CIRCULAR LETTER No. 22
SERVICE BULLETIN No. 05
to all distributors

**Checking and/or replacing flaps handle
part(s) for Sinus/Virus aircraft family**

Aircraft affected: SN.151 to SN.170
except: SN.168 and SN.169

Schematic of flaps handle

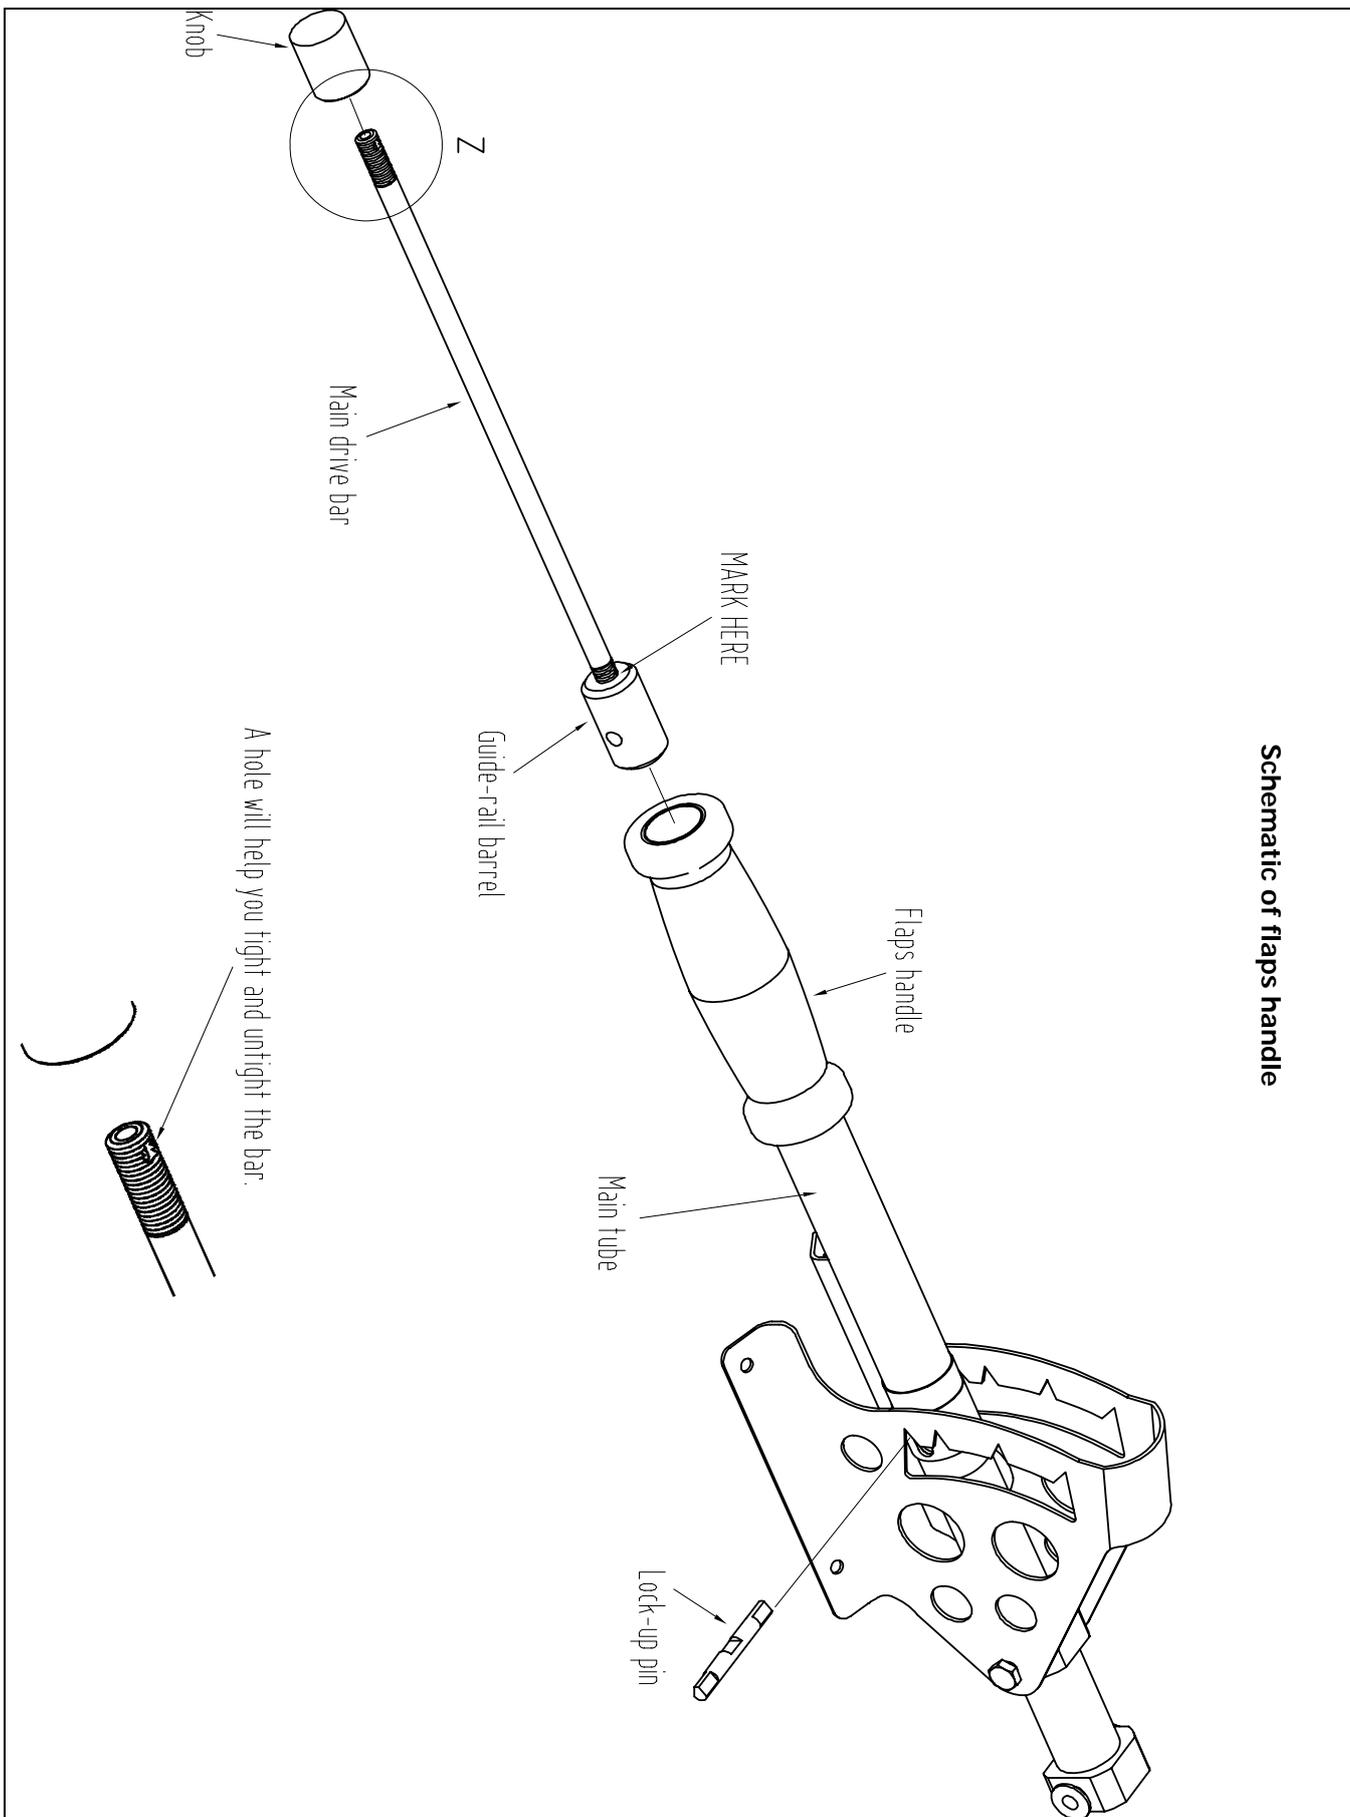
Inside the main metal tube of the flaps handle, there is a sliding guide-rail barrel which also holds the lock-up pin. This guide-rail barrel is made of plastic to ensure proper mechanism smoothness.

It appears that during high OATs (Outside Air Temperatures) the main metal tube of the flaps handle shrinks along its inner diameter, thus pressing onto the plastic guide-rail and blocking it completely.

You will need to partially disassemble the flaps handle. This is a simple task and does not require special tools or knowledge. Ultimately, the plastic guide-rail barrel will be replaced with a new one.

1. Unscrew and remove the casing of the flaps handle.
2. Grab the knob on the flaps handle with your fingers and unscrew it.
3. Unfasten the revealed metal drive bar only so much that it moves out by 8-10 mm (not completely!) - this will release pressure on the lock-up pin.

4. While applying pressure on the metal drive bar, grab the lock-up pin at the base of the handle with a pair of pincers and remove it completely.
5. Grasp the metal drive bar and remove it from the main flaps handle tube completely. Be careful not to lose any parts as there is a spring under pressure behind the metal bar.

6. Now you will see the plastic barrel at the other end of the metal drive bar. First mark the position of the plastic barrel with a marker-pen (this is important for reassembly) and then unscrew and remove the barrel.

7. Replace the barrel with the newly-supplied part and screw it exactly to the position you have marked previously.
8. Re-insert the metal drive bar into the main tube. Note that the holes in the new barrel must be in horizontal position.

9. While applying pressure on the metal bar re-insert the lock-up pin to its previous position. Make sure the pin has been inserted correctly (exactly in the middle of the main tube).

10. Fasten the metal drive bar until you can feel strong resistance (you can use a nail or similar pin which you insert into the hole at the end of the metal drive rod to increase torque).

11. Screw the knob back onto the end of the metal drive rod.
